IEEE Std C37.100.1™-2018

Errata to IEEE Standard for Common Requirements for High-Voltage Power Switchgear Rated Above 1000 V

Correction Sheet
Issued 23 August 2019

Figure 2 —Diagram of connections of a three-pole switching device

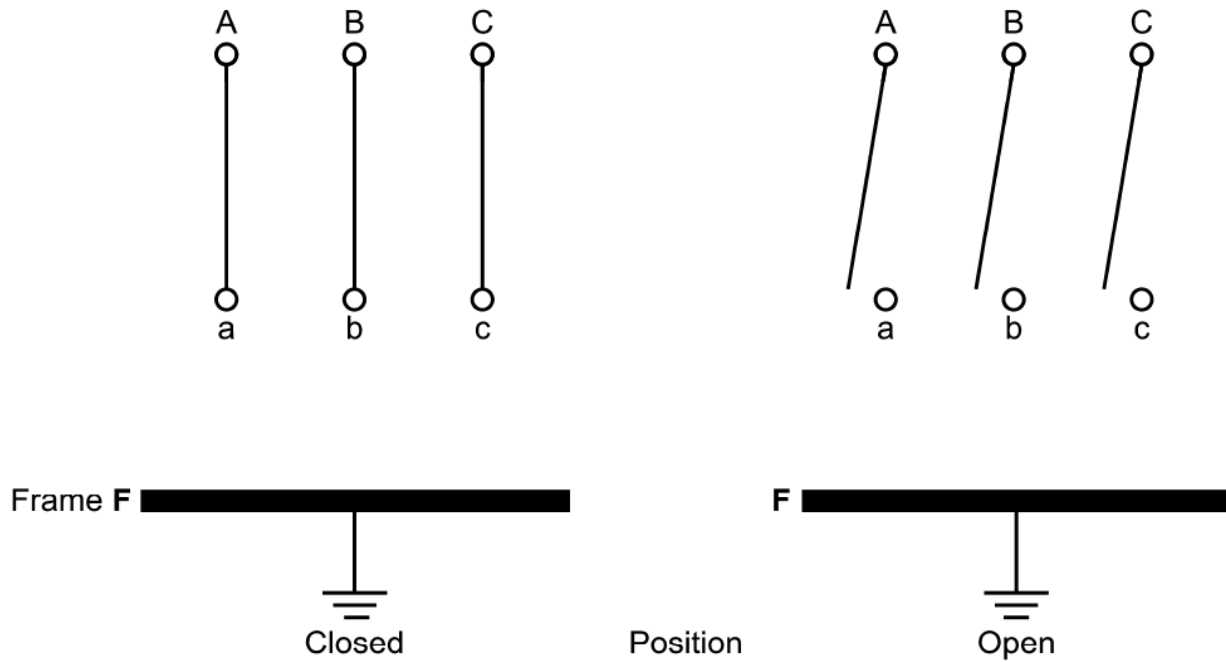
Insert the following Figure 2 after the third paragraph in 7.3.6.2:
